**Proposal for Amendment [3] to global technical regulation
No. 9 (Pedestrian safety)**

**Proposal of amendment to ECE/TRANS/WP.29/GRSP/2013/25,
Submitted by the expert from the European Commission and
Germany**

The text reproduced below was prepared by the experts from the European Commission and Germany to align the test requirements of UN GTR No. 9 Phase 2 with those of Amendment 2 to the UN GTR concerning the determination of the headform test points. It is based on ECE/TRANS/WP.29/GRSP/2013/25 and GRSP-54-07. The modifications to the current text of UN GTR No. 9 are marked in bold for new or strikethrough for deleted characters.

"Figure 6A

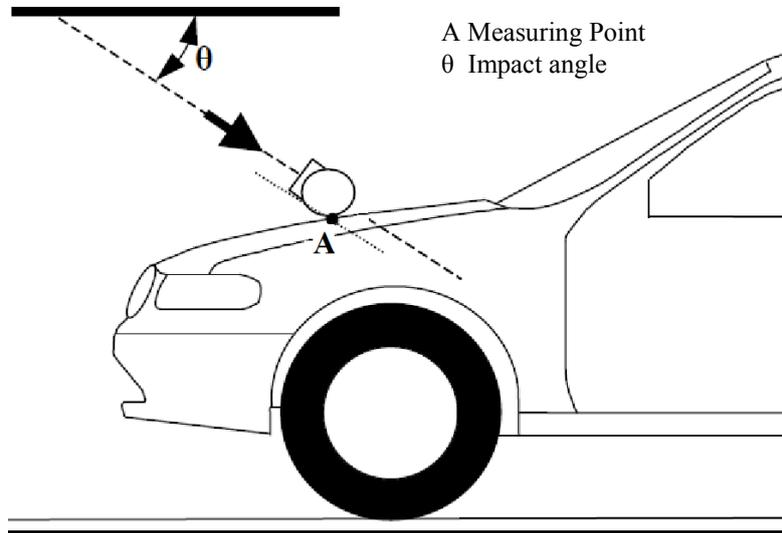
3.20.1. "Measuring point" for the headform test means a point on the vehicle's outer surface selected for assessment. The measuring point is where the headform's profile contacts the vehicle's outer surface cross section in a vertical longitudinal plane through the center of gravity of the headform (see Figure 6A).

Figure 6, shall be deleted

Figure 6B

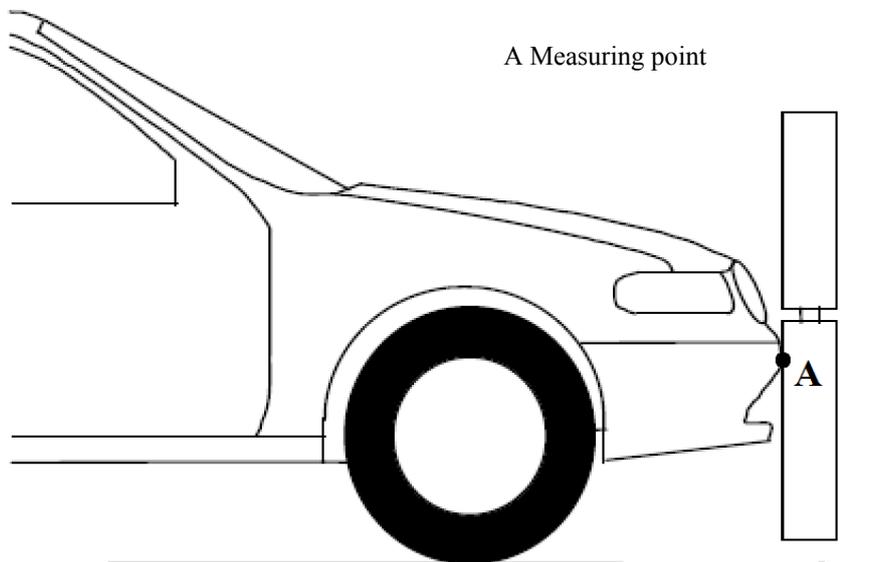
3.20.2. "Measuring point" for the lower legform to bumper test and the upper legform to bumper test is located in the vertical longitudinal plane through the central axis of the impactor (see Figure 6B). "

"Figure 11

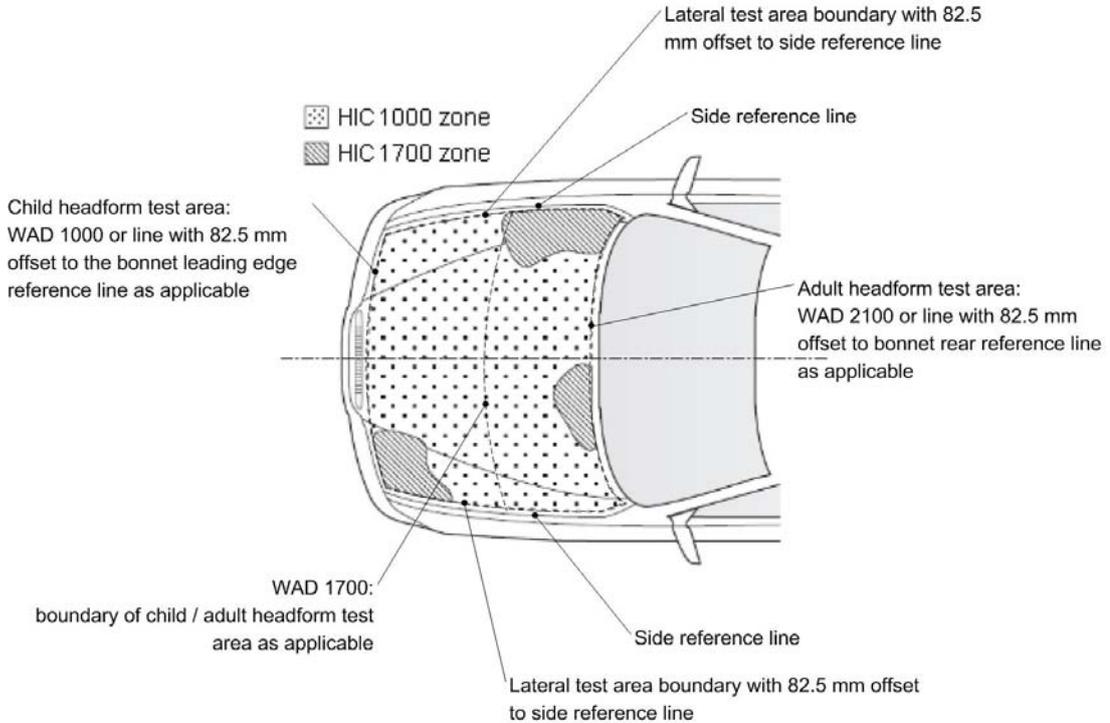
"5.2.4.1. The manufacturer shall identify the zones of the bonnet top **test area** where the HIC must not exceed 1,000 (HIC1000 Zone) or 1,700 (HIC1700 Zone) (see Figure 11)."

Figure 11(former), shall be deleted

Insert new Figure 11, to read:

Flexible lower legform impactor: Dimensions and centre of gravity locations of femur, knee joint and tibia (side view)

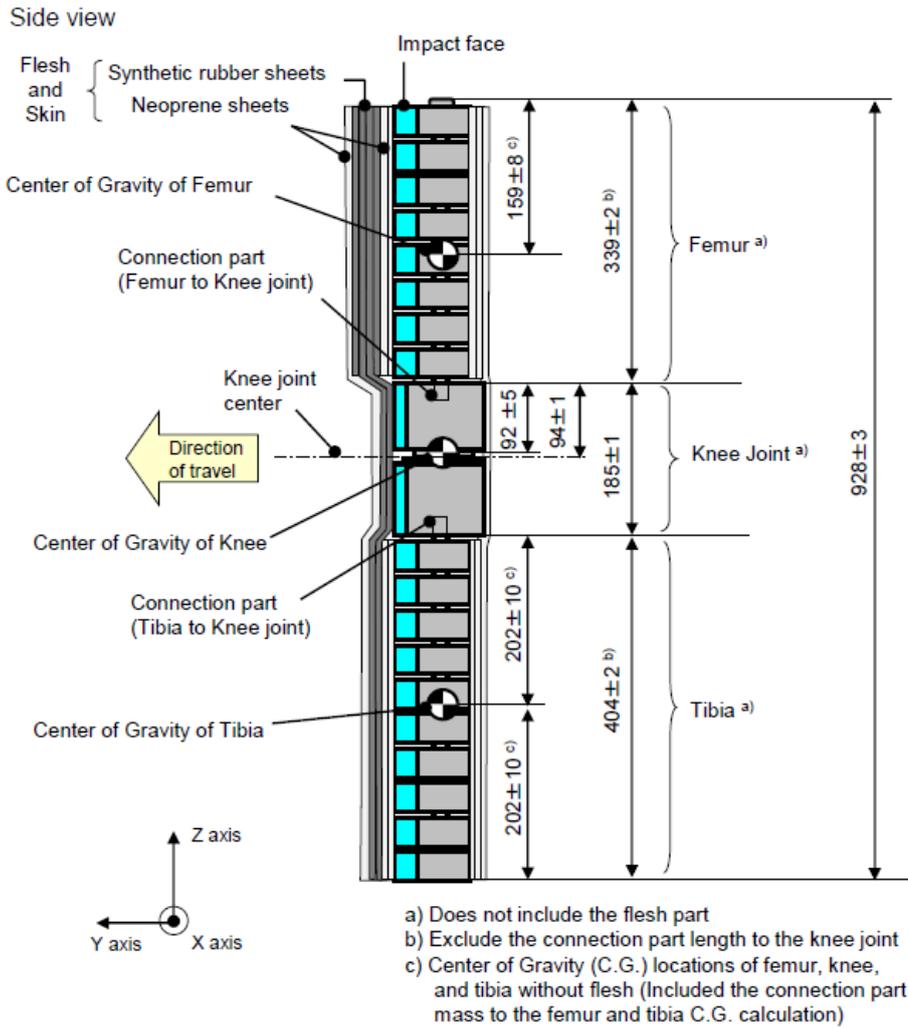
The flexible lower legform impactor shall consist of the flesh and skin, the flexible long bone segments (representing the femur and the tibia), and the knee joint as shown in Figure 12.

The centres of gravity of the femur and tibia without the flesh and skin, including the connection parts to the knee joint, shall be 159 ± 8 mm and 202 ± 10 mm respectively from the top, but not including the connection part to the knee joint, of each part as shown in Figure 12. The centre of gravity of the knee joint shall be 92 ± 5 mm from the top of the knee joint as shown in Figure 12.

Figure 12, shall be deleted:

Figure 13
Flexible lower legform impactor: Schematic plan views of femur, tibia, and knee dimensions (top view)

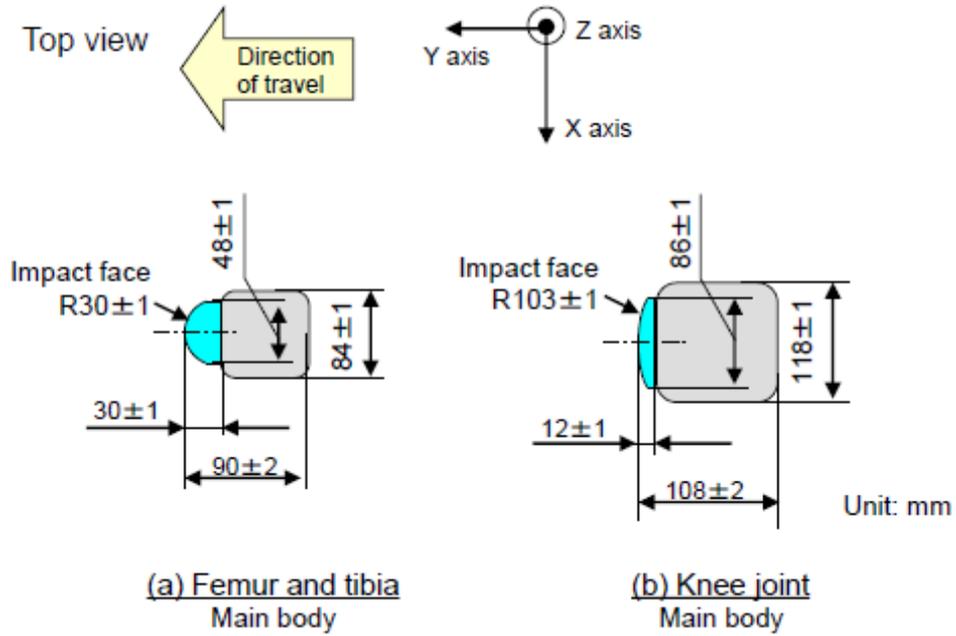
- 6.3.1.1.1. **The cross-sectional shape perpendicular to the Z-axis of the femur and the tibia main body segments shall be 90 mm in width along the Y-axis, and 84 mm in width along the X-axis as shown in Figure 13 (a). The impact face shall be 30 mm in radius, 30 mm in width along the Y-axis, and 48 mm in width along the X-axis as shown in Figure 13 (a).**

- 6.3.1.1.2. **The cross-sectional shape perpendicular to the Z-axis of the knee joint shall be 108 mm in width along the Y-axis, and 118 mm in width along the X-axis as shown in Figure 13 (b). The impact face shall be 103 mm in radius, 12 mm in width along the Y-axis, and 86 mm in width along the X-axis as shown in Figure 13 (b).**

Figure 14
Flexible lower legform impactor: Flesh and skin dimensions

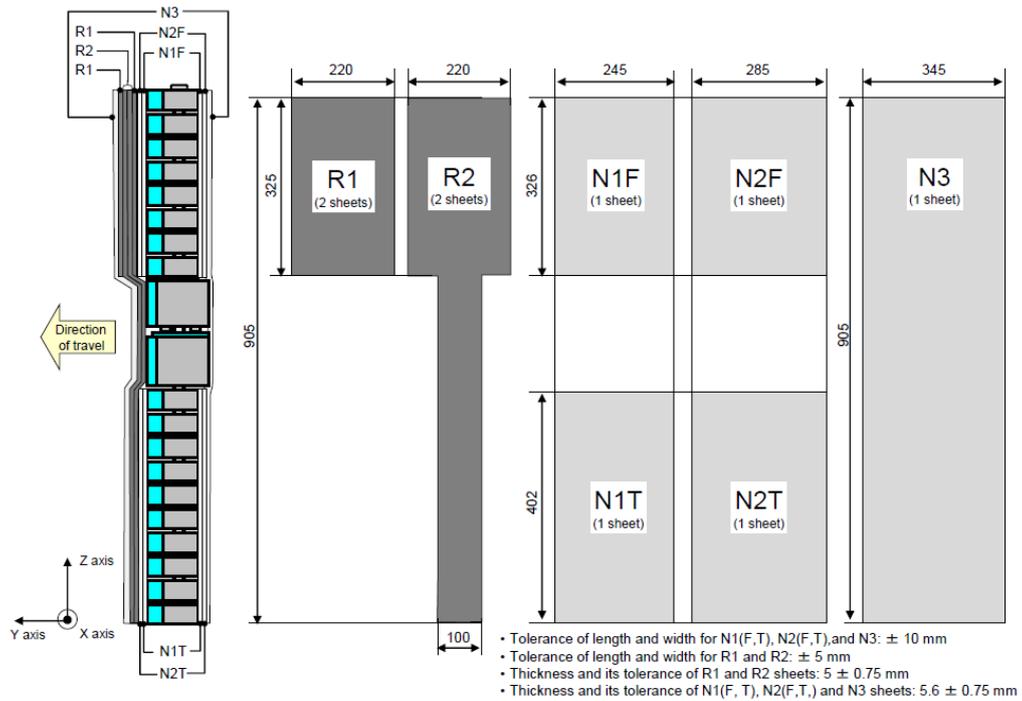
- 6.3.1.1.4. **For each test, the impactor (femur, knee joint and tibia) shall be covered by the flesh and skin composed of synthetic rubber sheets (R1, R2) and neoprene sheets (N1F, N2F, N1T, N2T, N3) as shown in Figure 14. The size of the sheets shall be within the requirements described in Figure 15. The sheets are required to have compression characteristics as shown in Figure 15. The compression characteristics shall be checked using material from the same batch as the sheets used for the impactor flesh and skin.**

Figure 16
Flexible lower legform impactor; Instrument

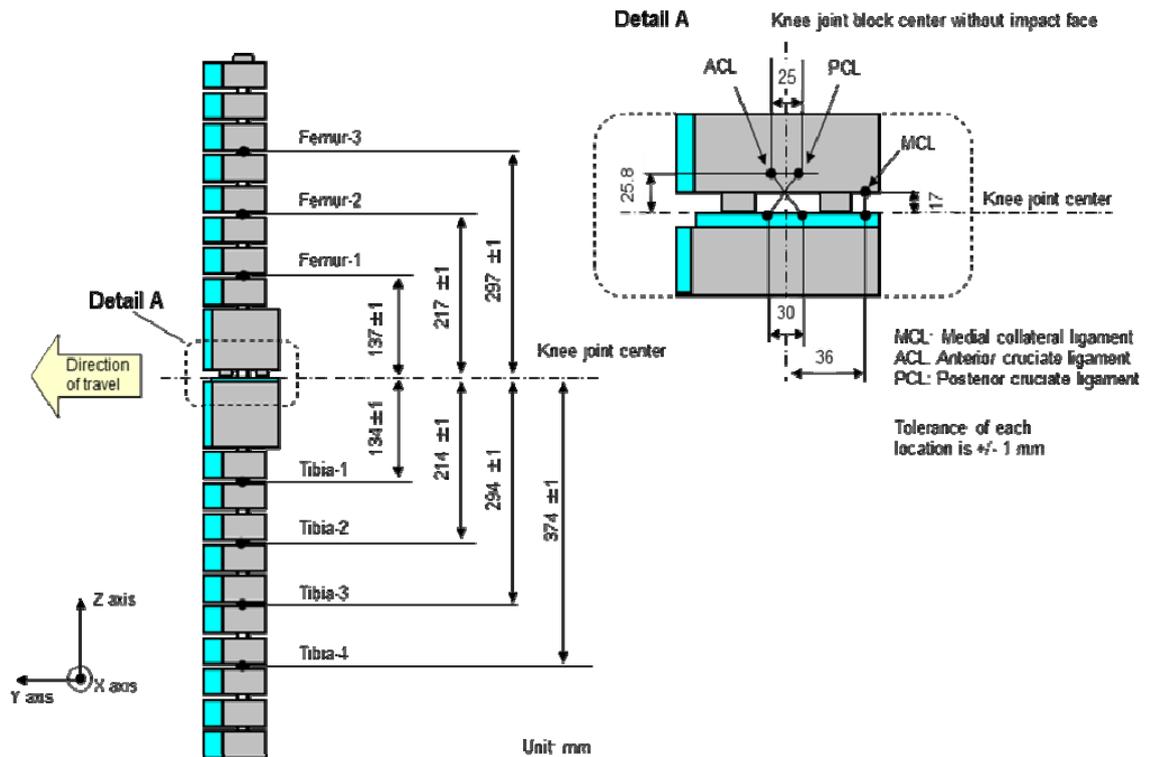
- 6.3.1.1.6.1. **Four transducers shall be installed in the tibia to measure bending moments at locations within the tibia. The sensing locations of each of the transducers are as follows: tibia-1: 134 mm, tibia-2: 214 mm, tibia-3: 294 mm and tibia-4: 374 mm below the knee joint centre respectively as shown in Figure 16.**

Three transducers shall be installed in the femur to measure bending moments applied to the femur. The sensing locations of each of the transducers are as follows: femur-1: 137 mm, femur-2: 217 mm and femur-3: 297 mm above the knee joint centre, respectively, as shown in Figure 16.

ligament (ACL), and posterior cruciate ligament (PCL). The measurement locations of each transducer are shown in Figure 16. The measurement locations shall be within ± 4 mm along the X-axis from the knee joint centre.

Tolerances of angles

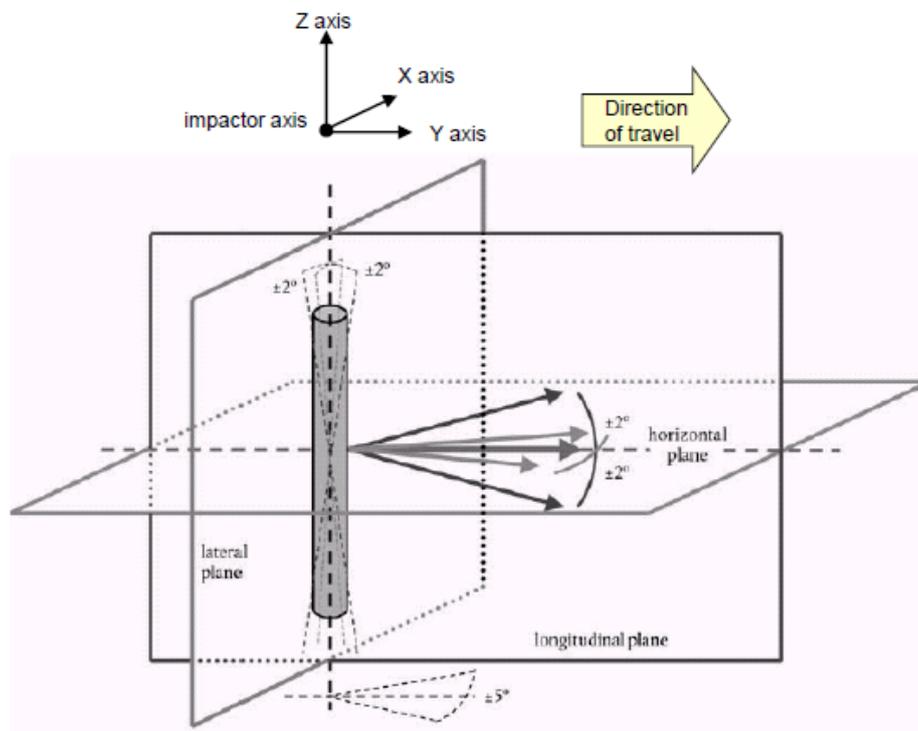
7.1.1.2. **The direction of the impact velocity vector shall be in the horizontal plane and parallel to the longitudinal vertical plane of the vehicle. The tolerance for the direction of the velocity vector in the horizontal plane and in the longitudinal plane shall be $\pm 2^\circ$ at the time of first contact. The axis of the impactor shall be perpendicular to the horizontal plane, with a roll and pitch angle tolerance of $\pm 2^\circ$ in the lateral and longitudinal plane. The horizontal, longitudinal and lateral planes are orthogonal to each other (see Figure 20).**

- 7.1.1.3.2. **At the time of first contact the impactor shall have the intended orientation about its vertical axis, for the correct operation of its knee joint, with a yaw angle tolerance of $\pm 5^\circ$ (see Figure 20).**

Figure 21

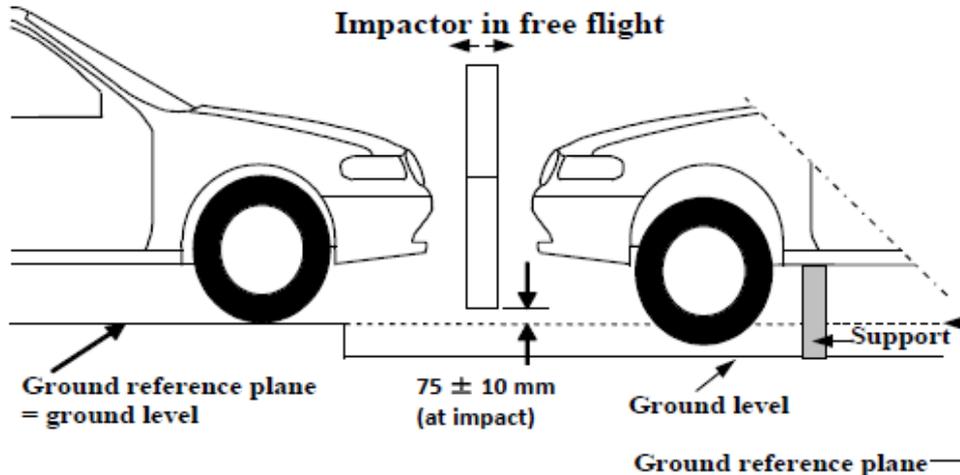
7.1.1.3. **The bottom of the impactor (without parts needed for the purposes of launching and/or protection) shall be 75 mm above the ground reference plane at the time of the first contact with the bumper (see Figure 21), with a tolerance of ± 10 mm. When setting the height of the propulsion system, an allowance must be made for the influence of gravity during the period of free flight of the impactor.**

Flexible lower legform impactor: Requirement corridors of the femur and the tibia in the static certification test (see paragraph 8.1.1.2.)

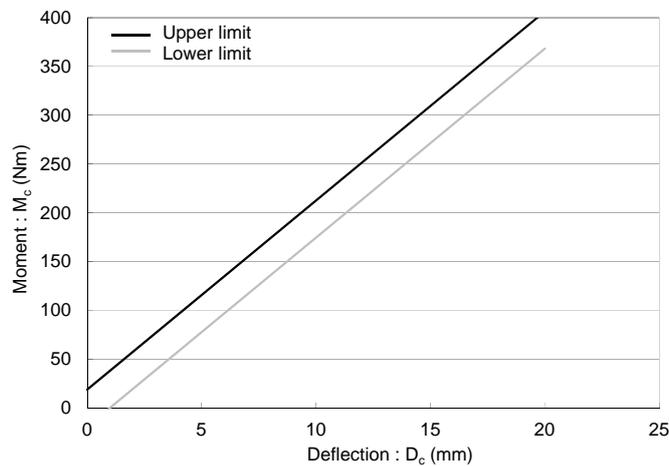
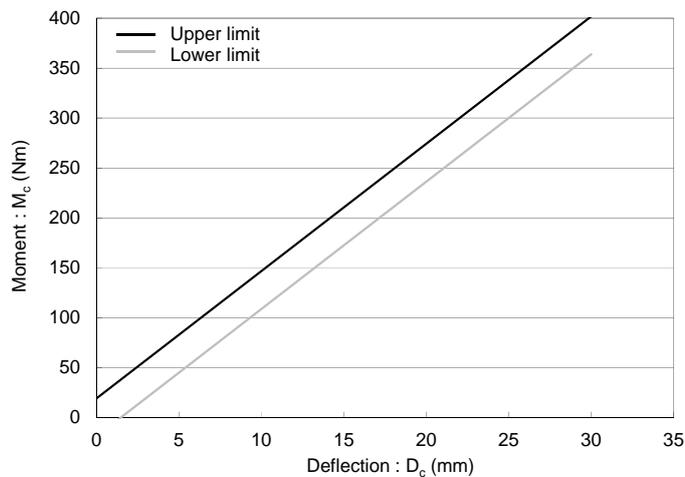
8.1.1.2. **When the femur and the tibia of the impactor are loaded in bending in accordance with paragraph 8.1.1.4, the applied moment and the generated deflection at the centre of the femur and the tibia (M_c and D_c) shall be within the corridors shown in Figure 22.**

Figure 23
Flexible lower legform impactor: Requirement corridors for the knee joint in the static certification test (see paragraph 8.1.1.3.)

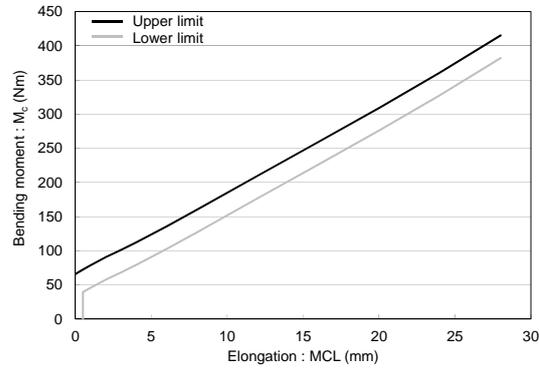
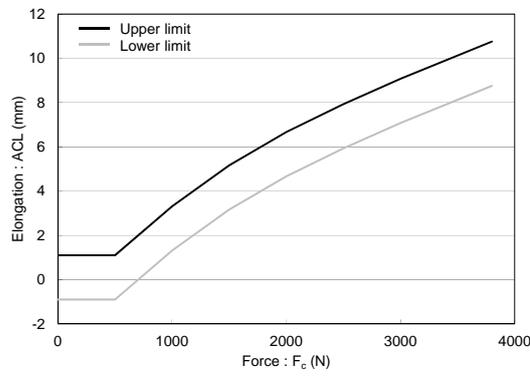
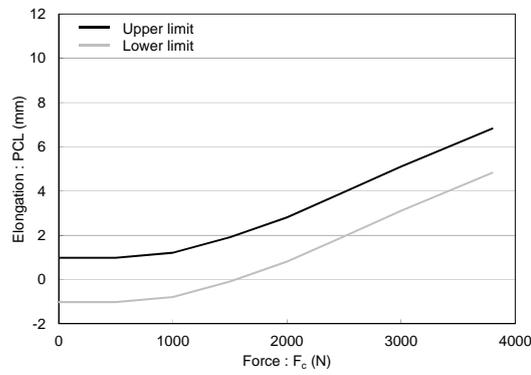
8.1.1.3. **When the knee joint of the impactor is loaded in bending in accordance with paragraph 8.1.1.5, the MCL, ACL, and PCL elongations and applied bending moment or the force at the centre of the knee joint (M_c or F_c) shall be within the corridors shown in Figure 23.**

Figure 24
Flexible lower legform: Impactor test set-up for the femur in the static certification test (see paragraph 8.1.1.4.)

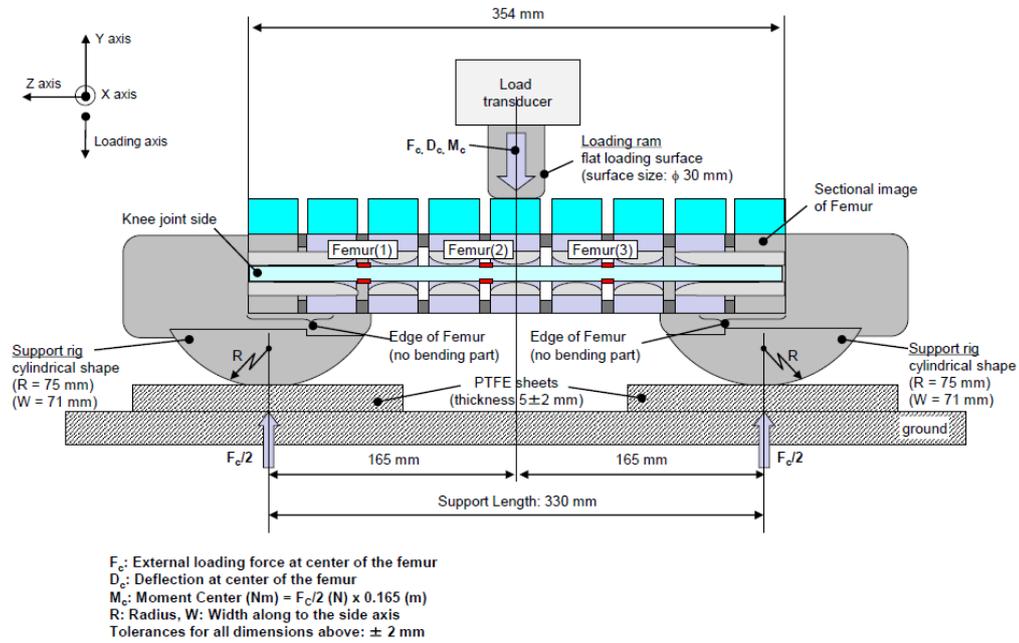
- 8.1.1.4. **The edges of the femur and tibia, not bending parts, shall be mounted to the support rig firmly as shown in Figure 24 and Figure 25. The Y-axis of the impactor shall be parallel to the loading axis within $180 \pm 2^\circ$ tolerance. To obtain repeatable loading, low friction Polytetrafluoroethylene (PTFE) plastic pads are used under each support (see Figure 24 and Figure 25).**

Figure 26
Flexible lower legform impactor: Test set-up for the knee joint in the static certification test (see paragraph 8.1.1.5.)

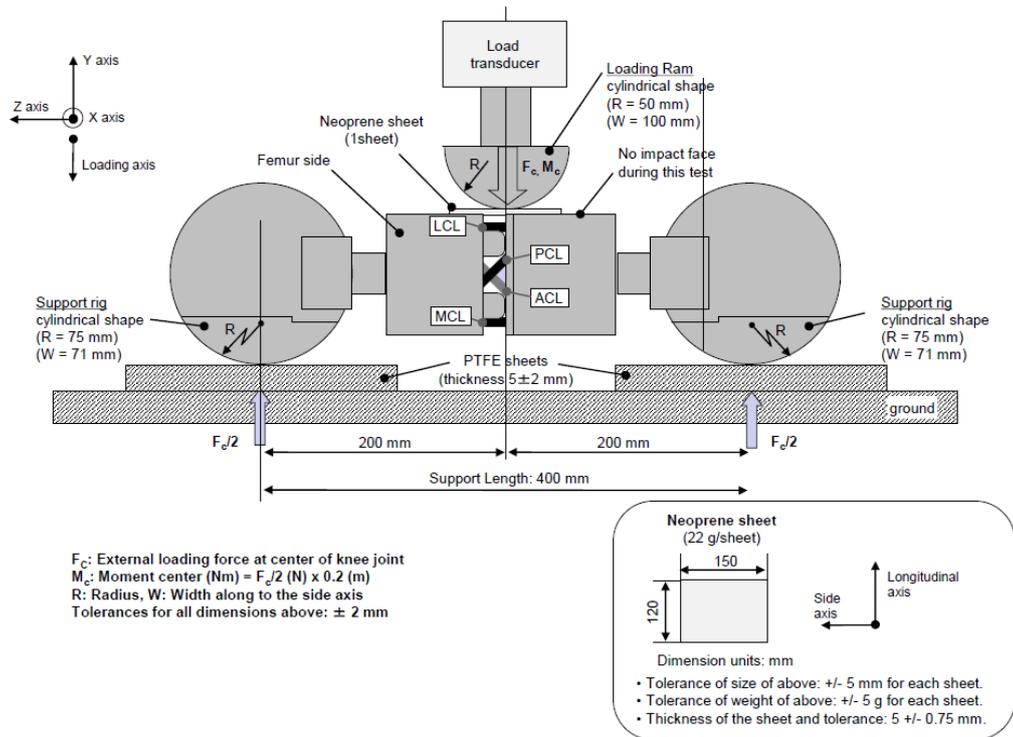
- 8.1.1.5. **The ends of the knee joint shall be mounted to the support rig firmly as shown in Figure 26. The Y-axis of the impactor shall be parallel to the loading axis within $\pm 2^\circ$ tolerance. To obtain repeatable loading, low friction Polytetrafluoroethylene (PTFE) plastic pads are used under each support (see figure 26). To avoid impactor damage, a neoprene sheet shall be set underneath the loading ram and the impactor face of the knee joint which is described in the Figure 13 shall be removed. The neoprene sheet used in this test shall have compression characteristics as shown in Figure 15.**

Figure 27
Flexible lower legform impactor: Test set-up for the dynamic lower legform impactor certification test (pendulum test, see paragraph 8.1.2.4.)

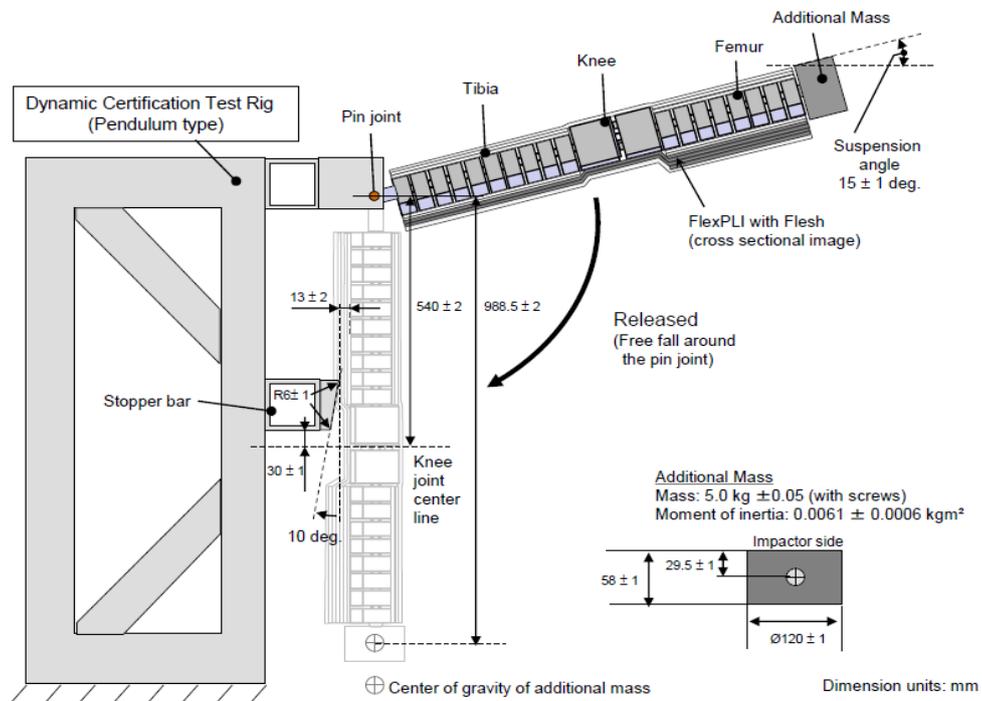
- 8.1.2.4.1. **The flexible lower legform impactor, including the flesh and skin, shall be suspended from the dynamic certification test rig $15 \pm 1^\circ$ upward from the horizontal as shown in Figure 27. The impactor shall be released from the suspended position and fall freely against the pin joint of the test rig as shown in Figure 27.**

- 8.1.2.4.2. **The knee joint centre of the impactor shall be 30 ± 1 mm below the bottom line of the stopper bar, and the tibia impact face without the flesh and skin shall be located 13 ± 2 mm from the front upper edge of the stopper bar when the impactor is hanging freely as shown in Figure 27.**
